Access Compliance Report

Public Rights-of-Way

(Curb Ramps)

Intersection ID: 50591	Main Street: GREEN_GRASS_RD	Cross Street: LONGSTRAW_RD	Location: NE
ADA ID: 9FB4F2684DAD	Ramp Type: Perp	Initial Pass/Fail: Pass	Overall Compliance: No
Severity Score: 5			
Codes/Mitigation Info/Possible Solution		Field Measurements/Component Compliance

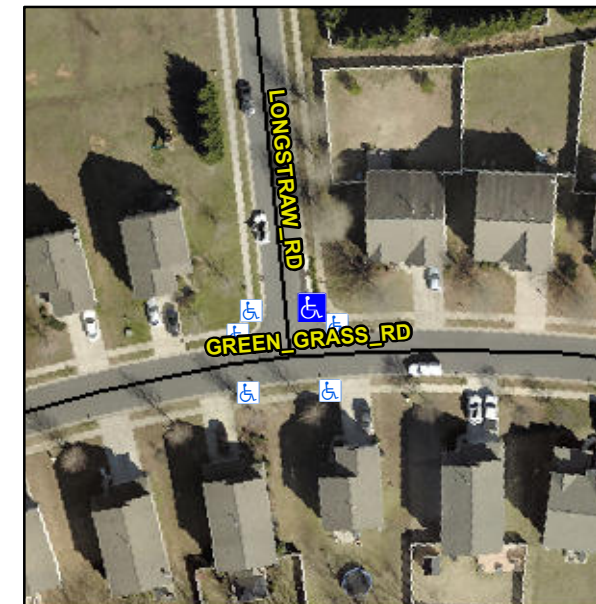
**Remove & Replace Landing.
Remove & Replace Gutter.**

**R304.2.1, R304.2.2-Perp, R304.3.2-
Para, R304.5.3, R302.7, R304.5.4**
